SERVICE BULLETIN

MITSUBISHI MOTORS

PURPOSE : CHANGE	ISSUE NO. : MSB-14EXML51-002	DATE : 2014-02-27
SUBJECT : CHANGE OF THE NUMBER OF RIVETS IN THE FRONT BUMPER REINFORCEMENT B		<DESTINATION/MODEL> (AS PER ATTACHED 1) ASX/RVR(GA0W) <M/Y> 13-14
GROUP : EXTERIOR

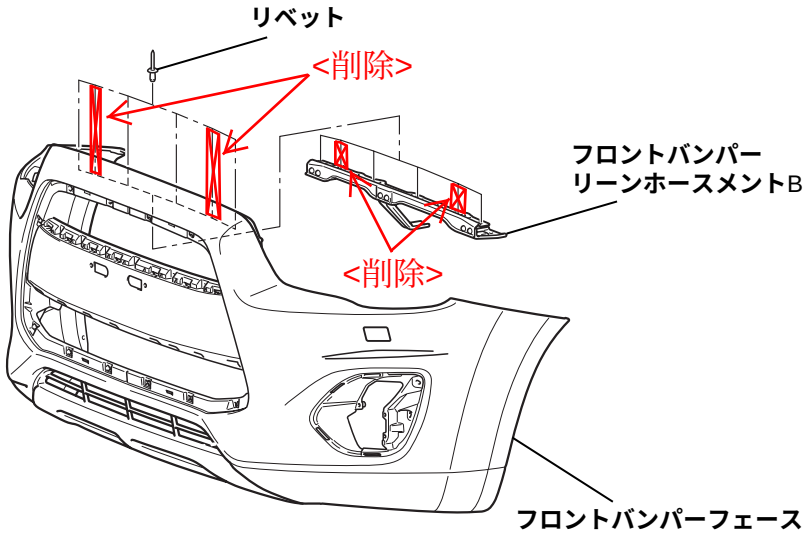
Please refer to the attached document for the information about the change of mention in the applicable service manual.(The number of the rivets in the front bumper reinforcement B is changed from 6 pieces to 4pieces)

Attached sheet 2

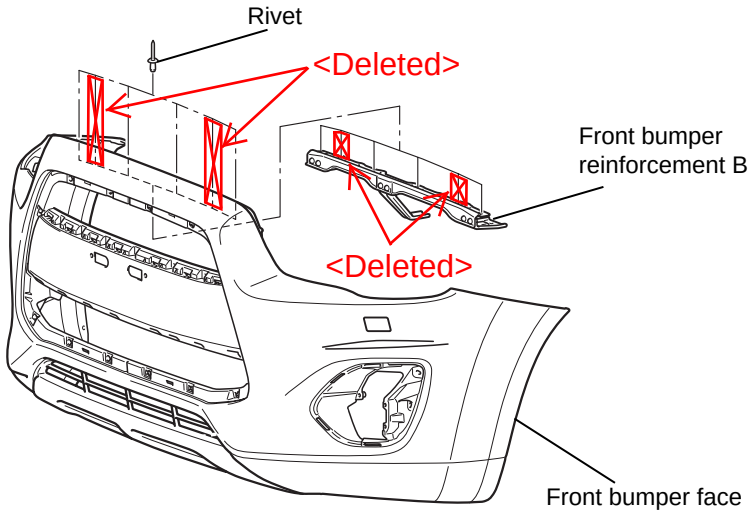
フロントバンパーリーンホースメントBの取付けリベットの数を６個から４個に変更した。

The number of the rivets, which secure front bumper reinforcement B to the body, has been decreased from six to four.
